New High School in Bungendore

State Significant
Development Application
(SSD-14394209)

Architectural + Landscape Design Report Addendum

Rev B
September 2022
Project No. 200096

7 Block B Design Amendments

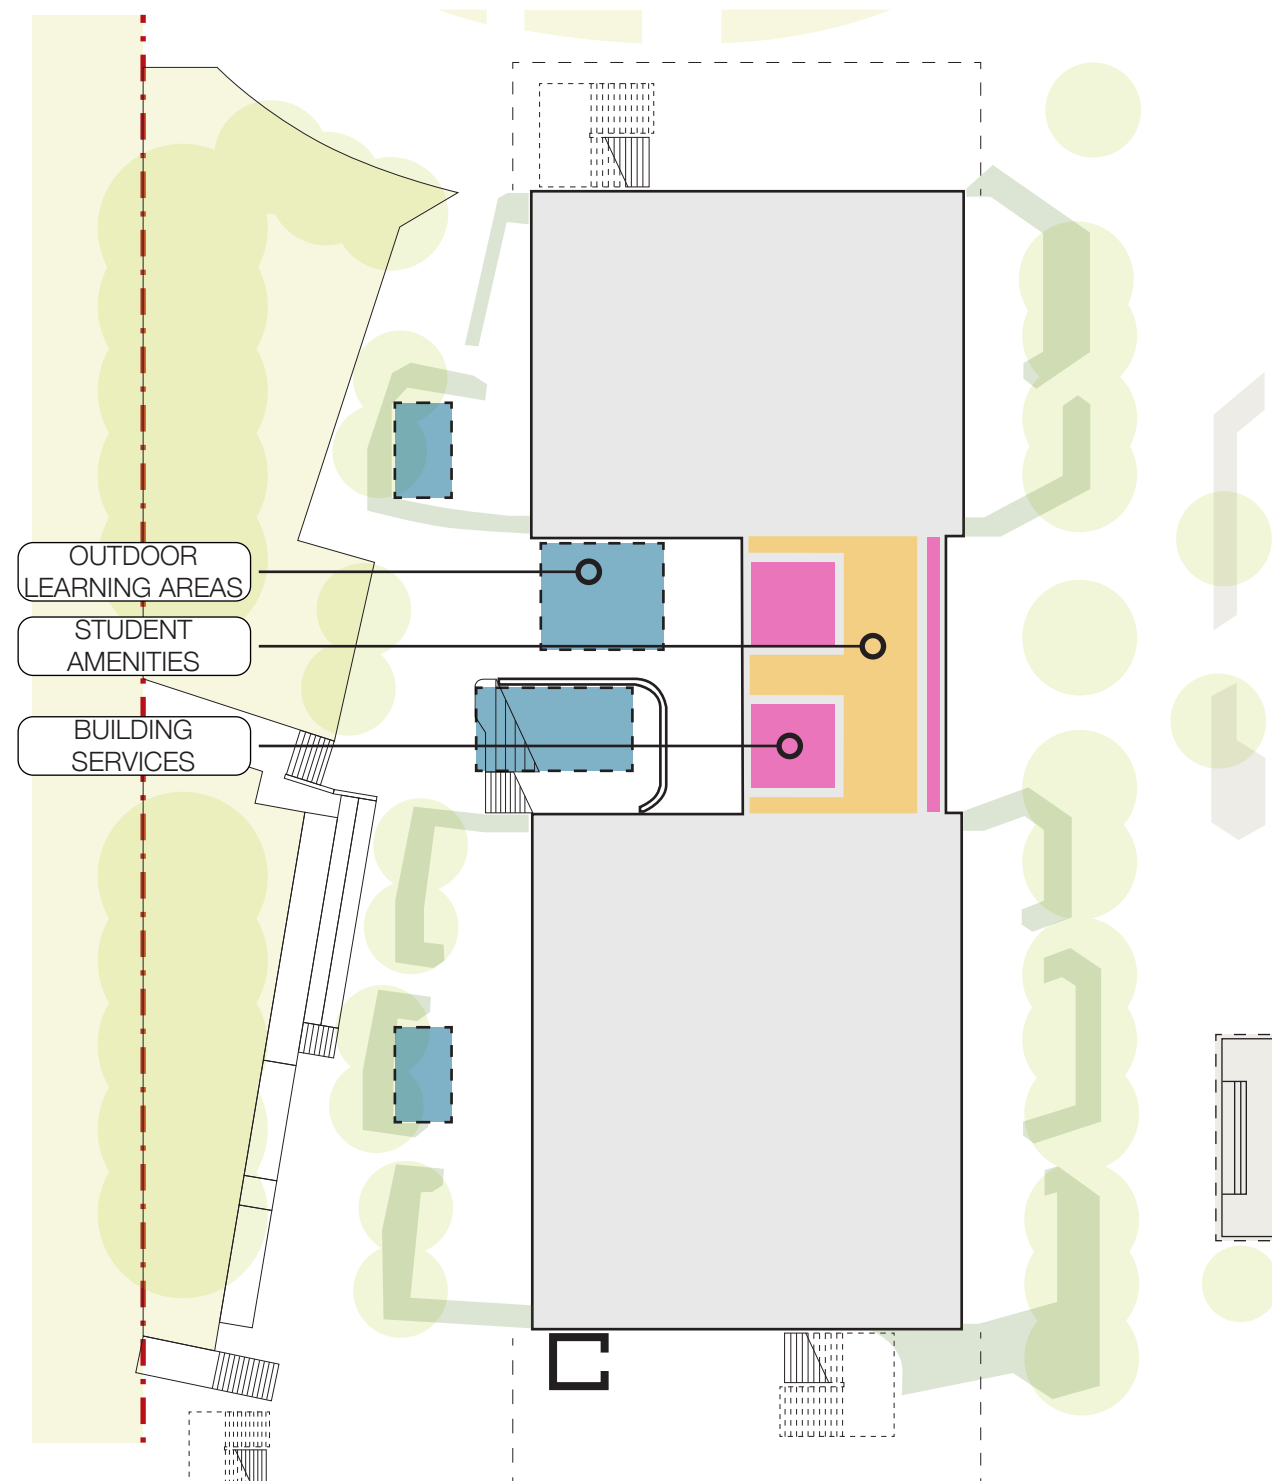
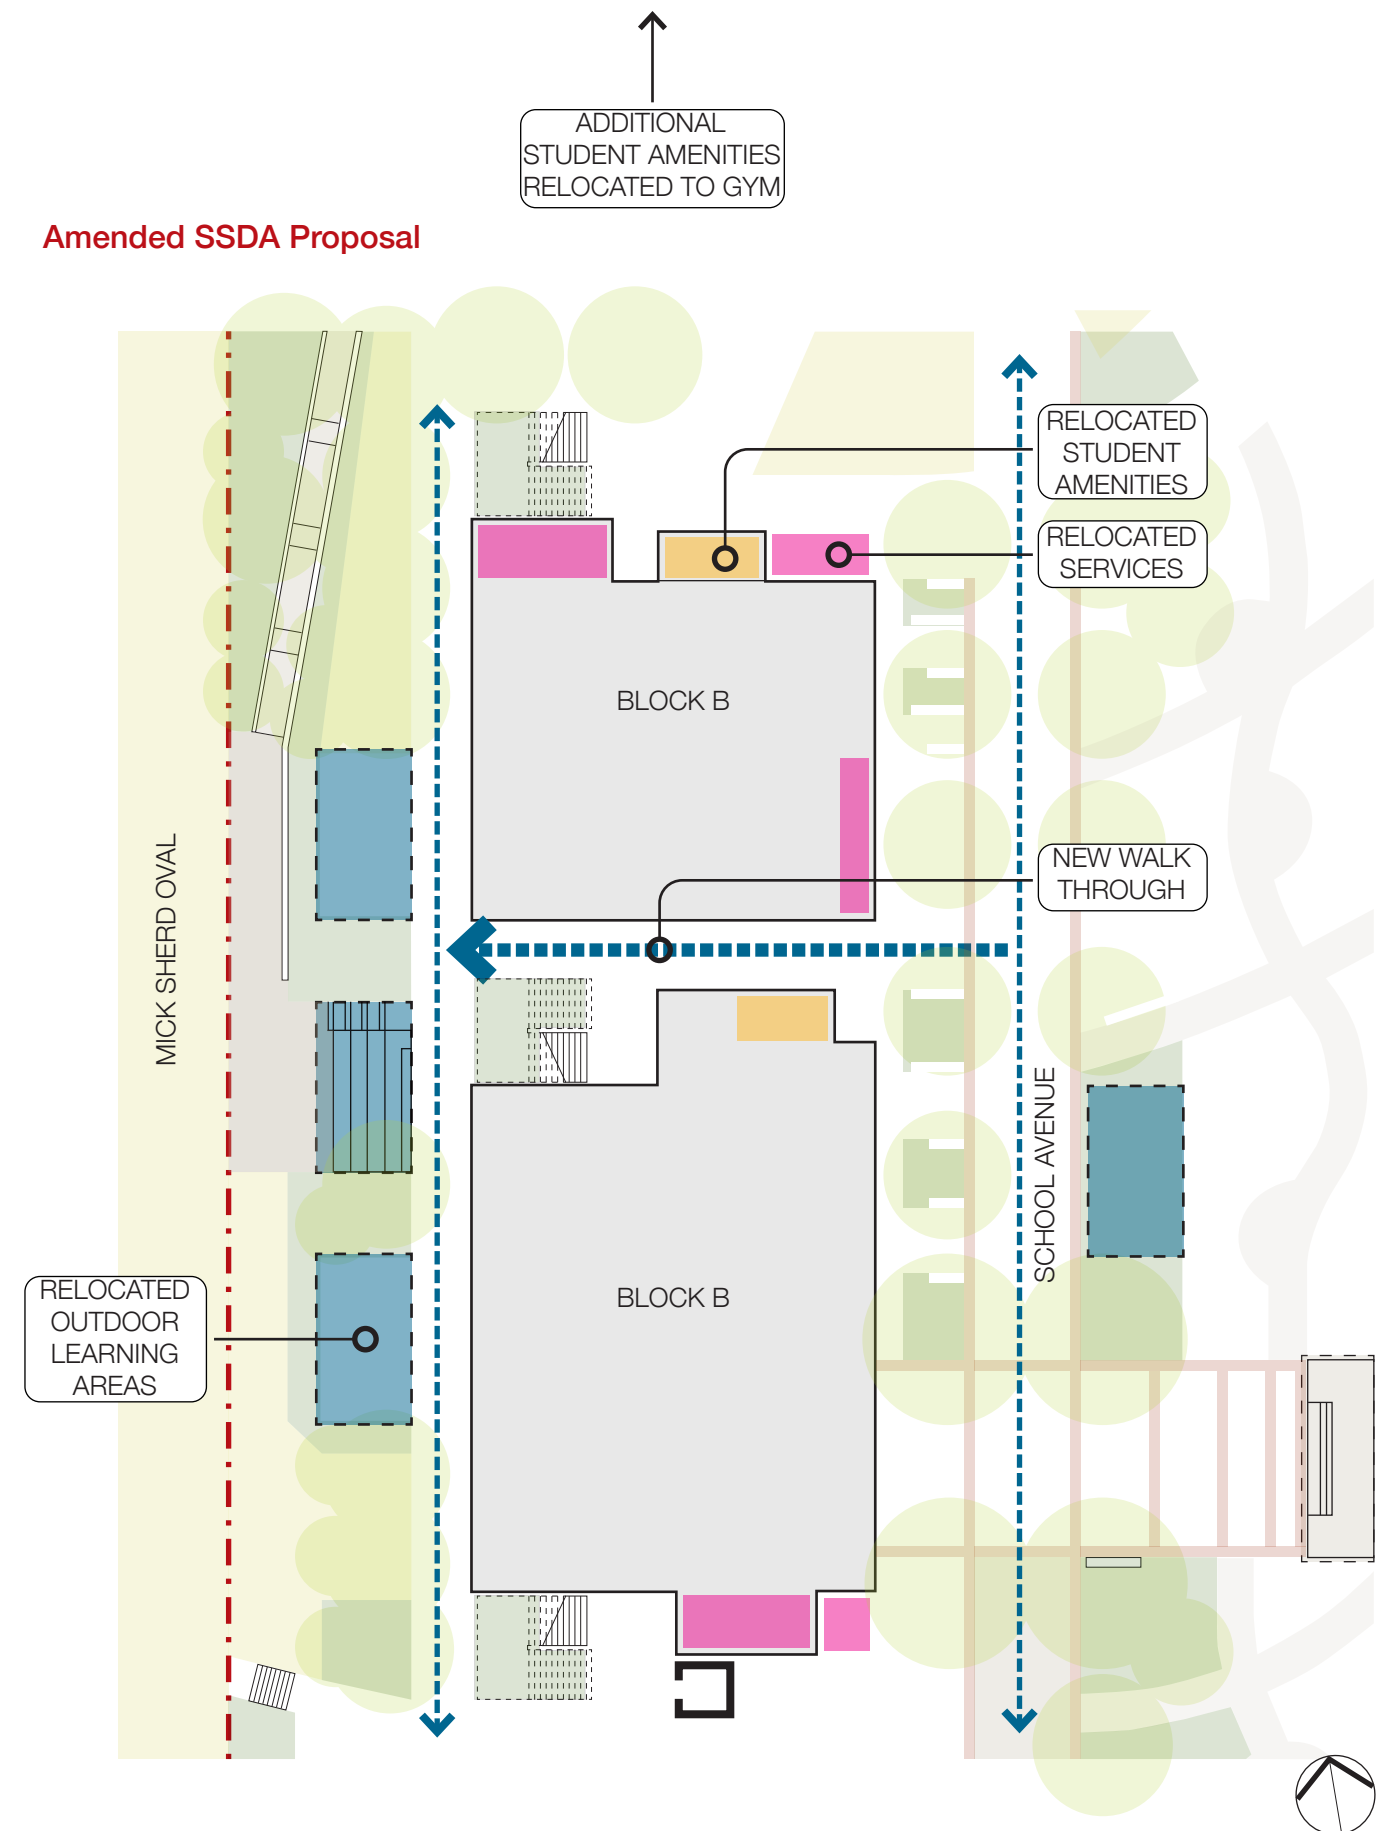
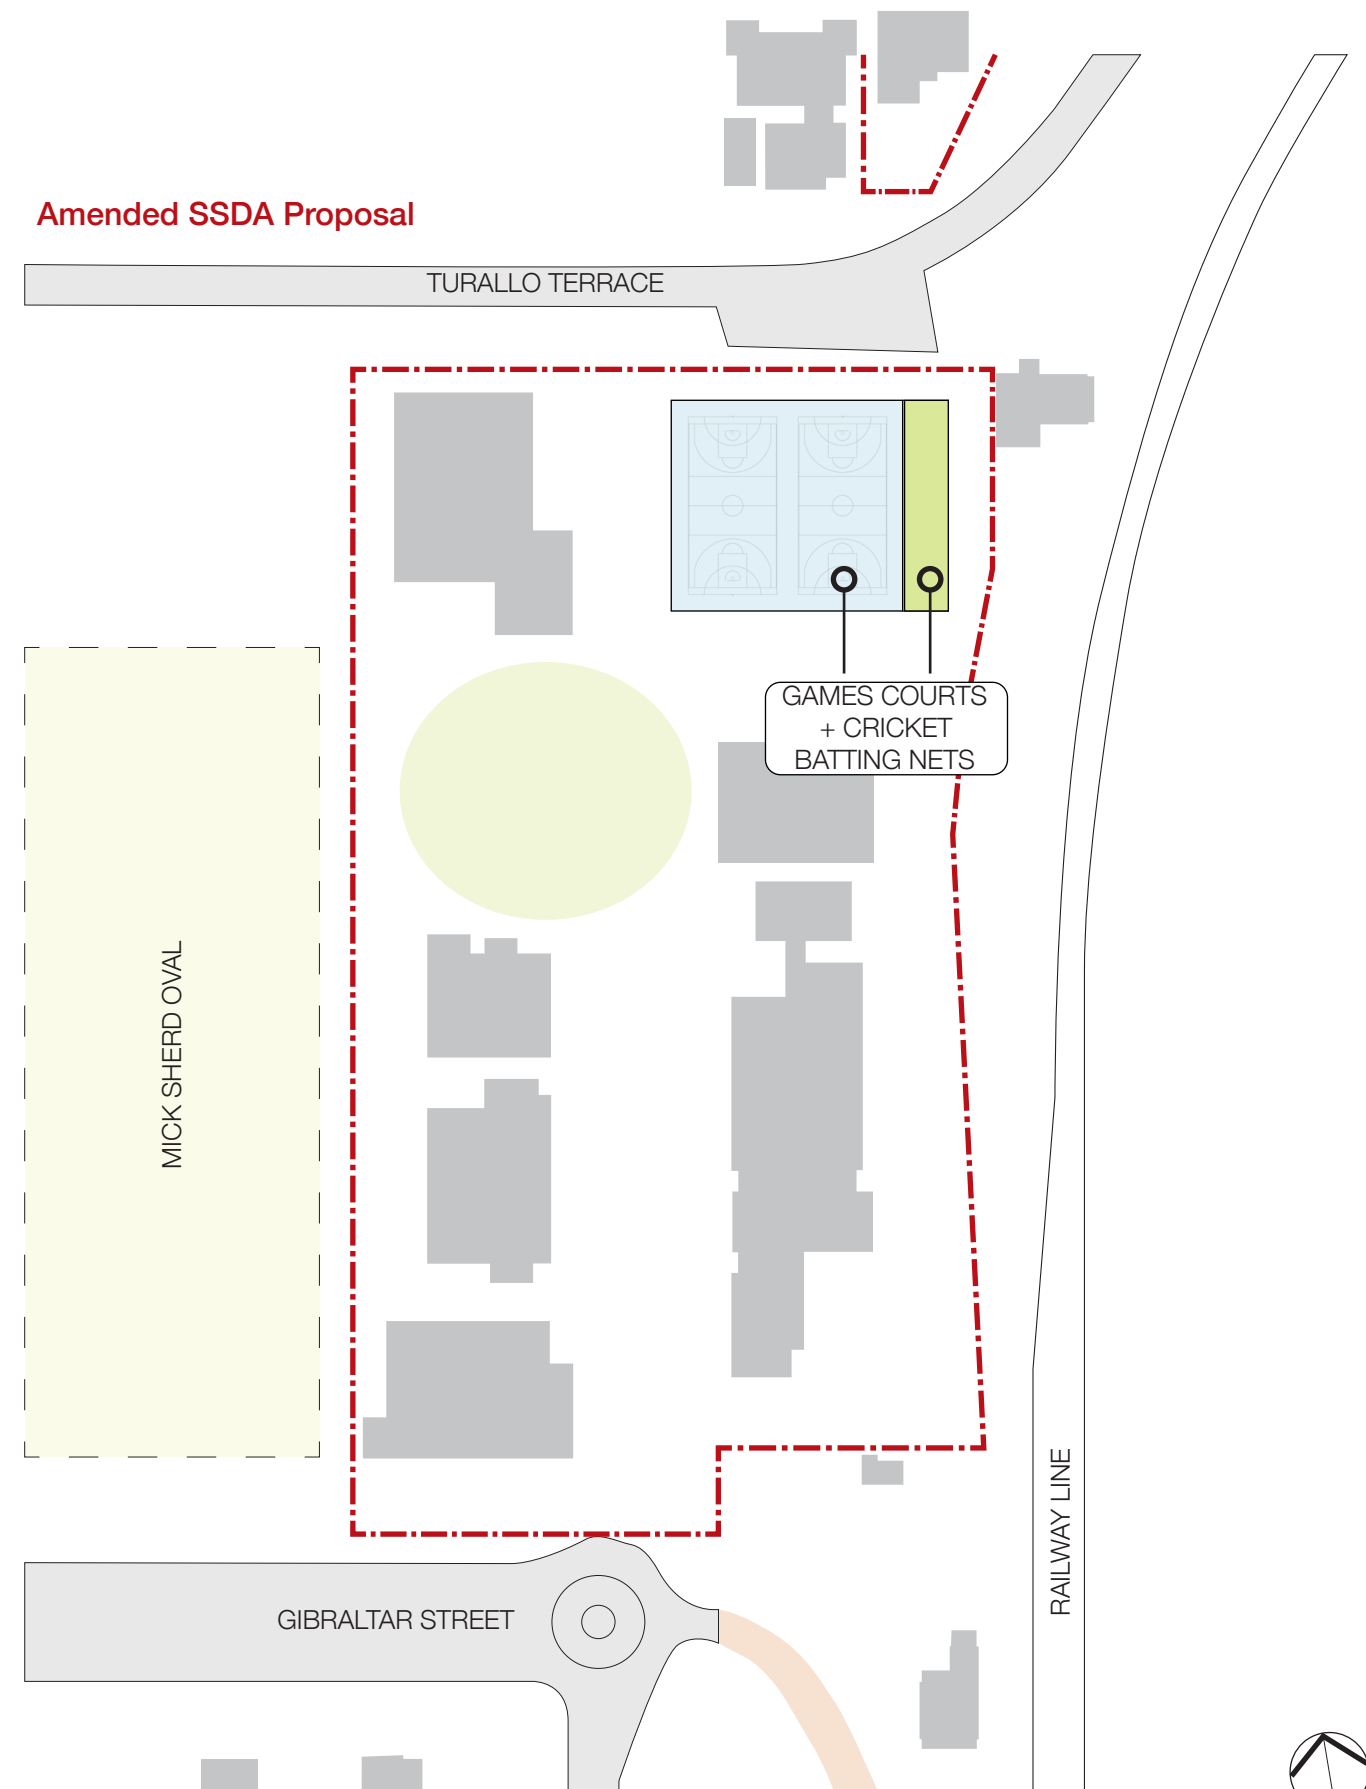
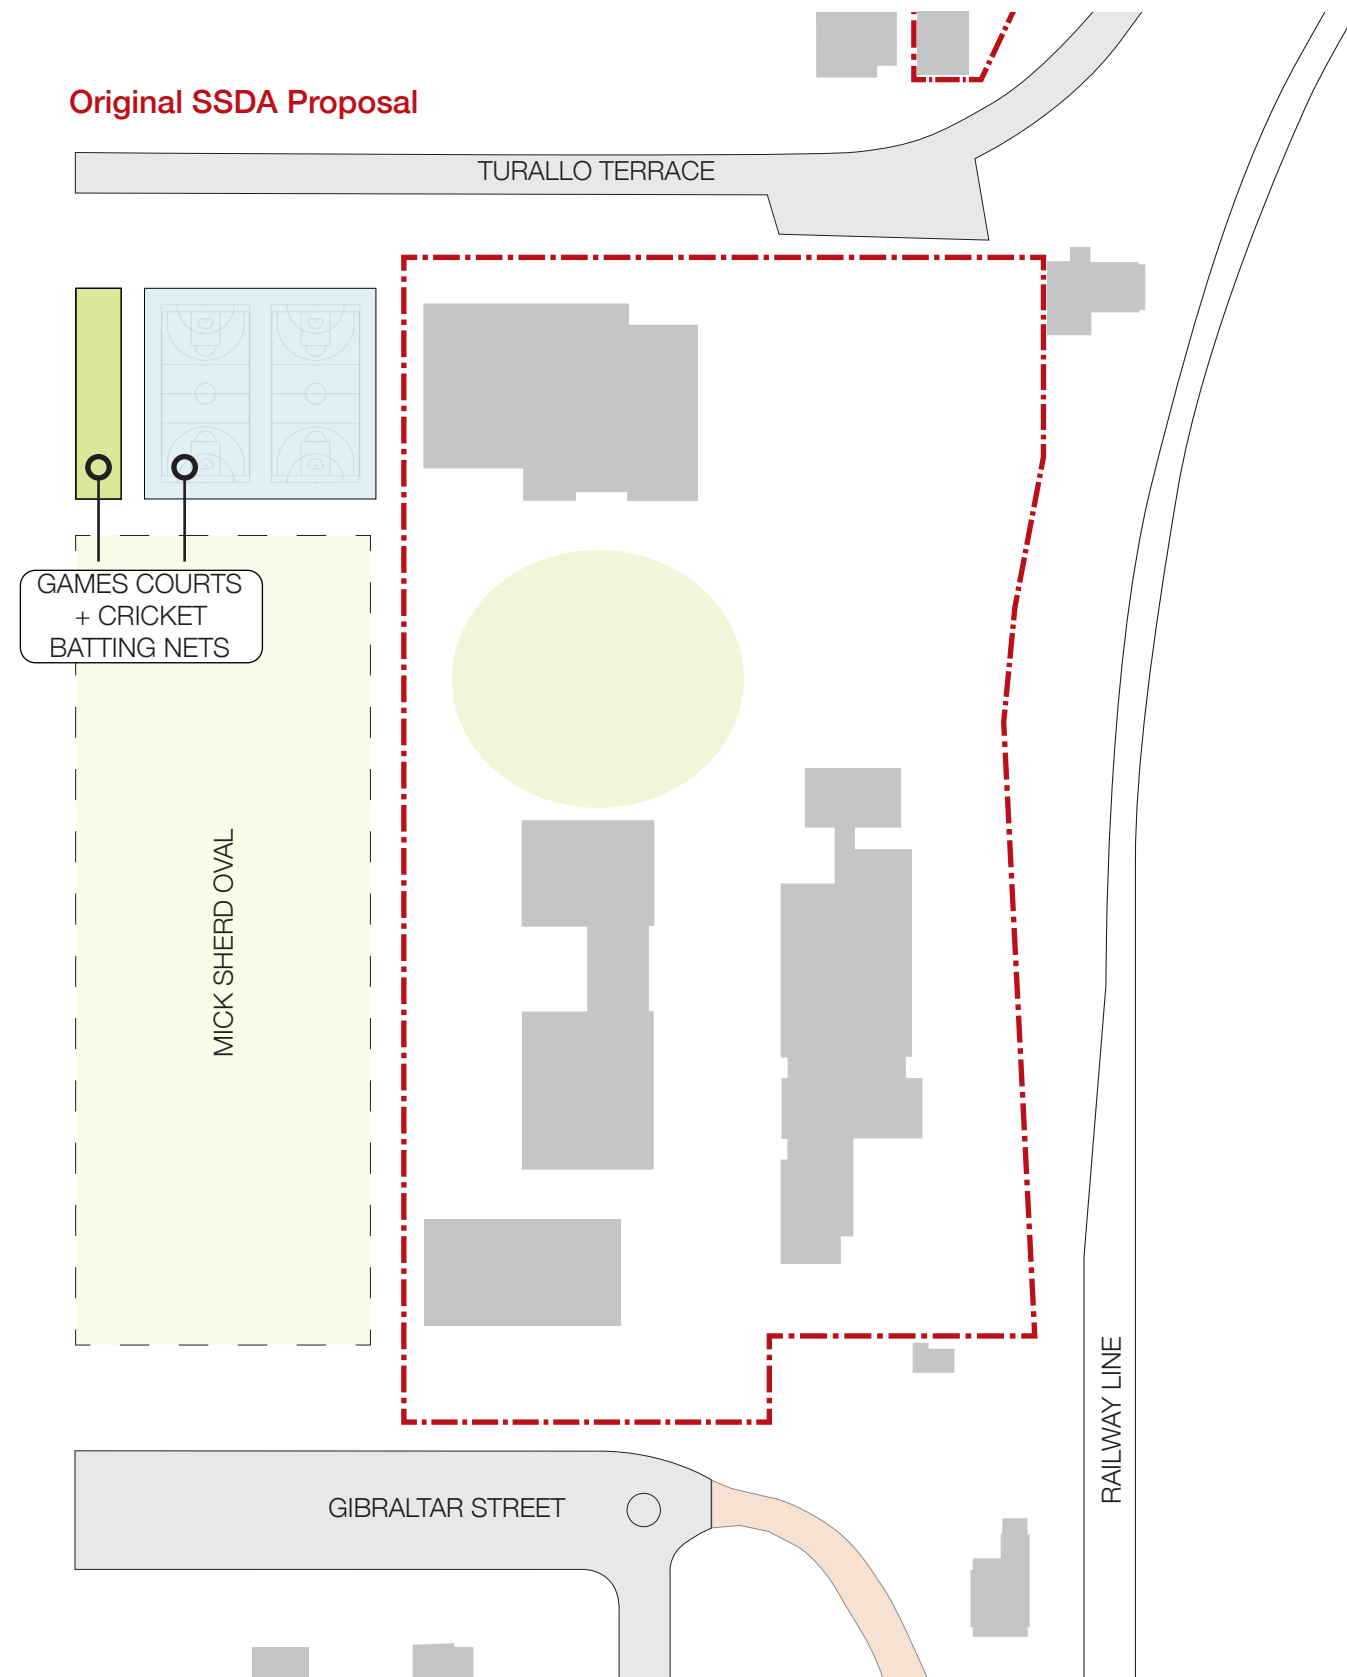
The student amenities, building services and outdoor learning spaces have been redistributed and redesigned to provide a new walk through to the centre of Block B, improving the connection between the School Avenue and the Mick Sherd Oval.

9 Reduced Bulk and Scale - Block A

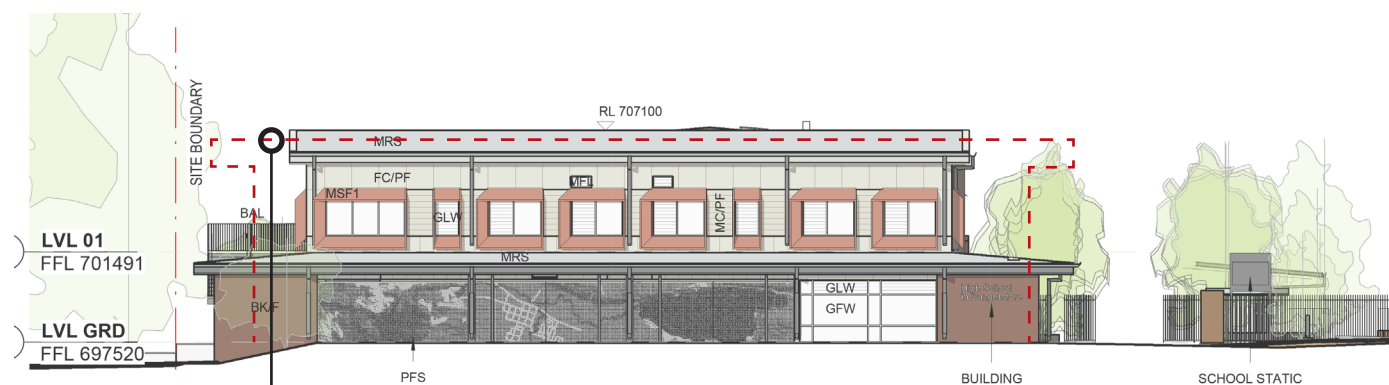
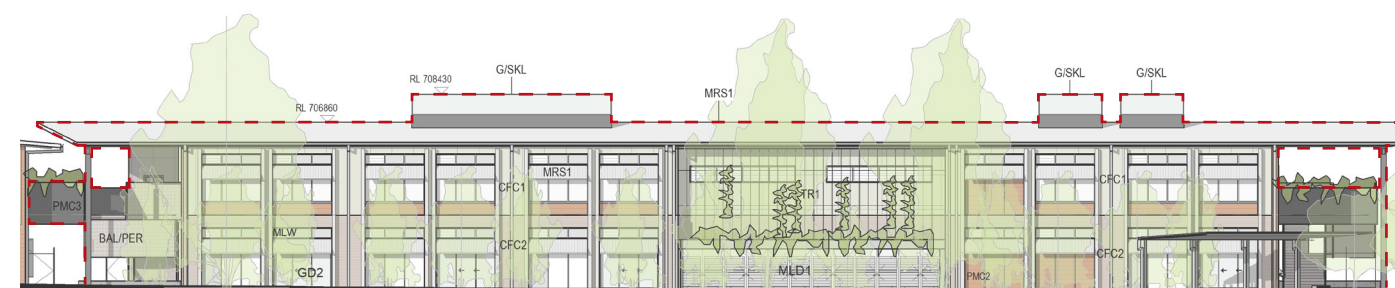
The Bulk and Scale of buildings facing public spaces has been reduced.

Block A has been redesigned to have a single storey element wrapping the south, east and west facades. The revised functions within Block A have also reduced the length of the two storey mass along the southern facade

9 Reduced Bulk and Scale - Block B

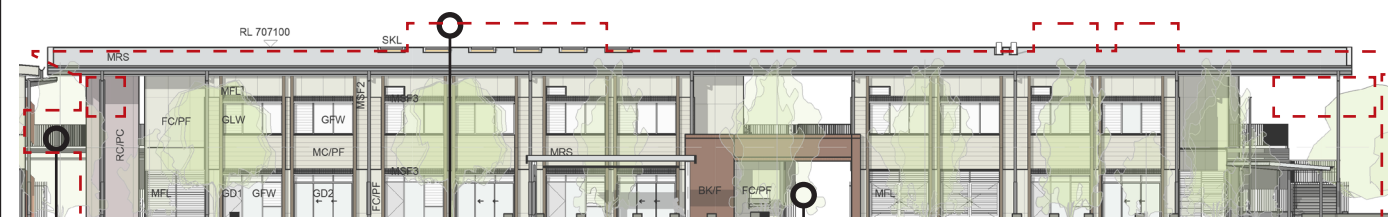
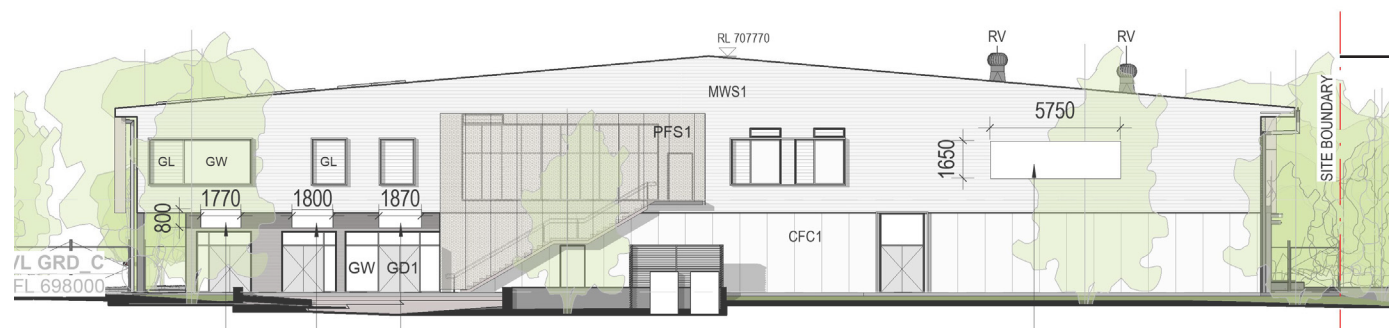
The Bulk and Scale of buildings facing public roads has been reduced.

The replanning of Block B to provide a new east west connection and the redesign of balustrades provides a more permeable frontage to the Mick Sherd Oval, reducing bulk and scale.

9 Reduced Bulk and Scale - Block D

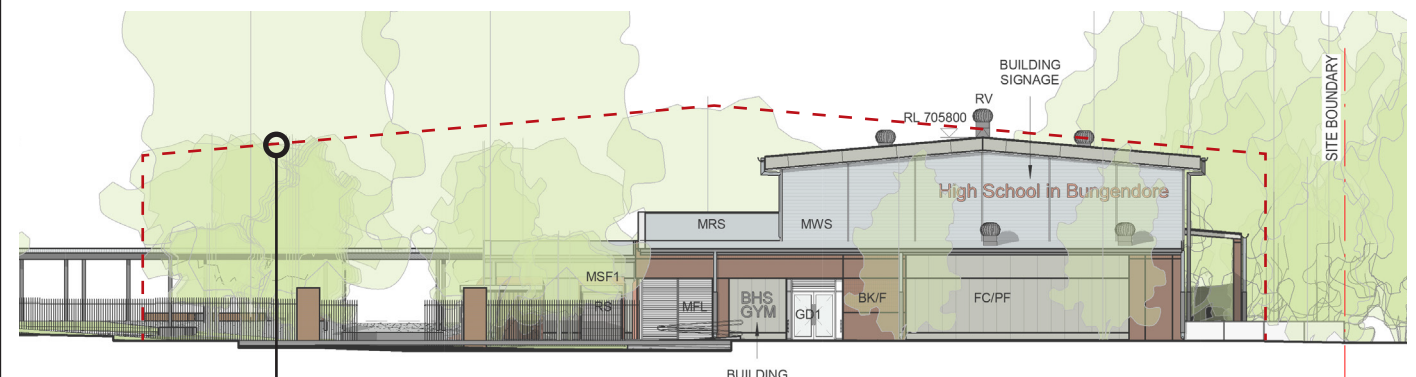
The Bulk and Scale of buildings facing public roads have been reduced.

Block D has been redesigned to have a single storey form to all 4 facades. The removal of the community facilities and relocation of the school library also contribute to the reduced scale.
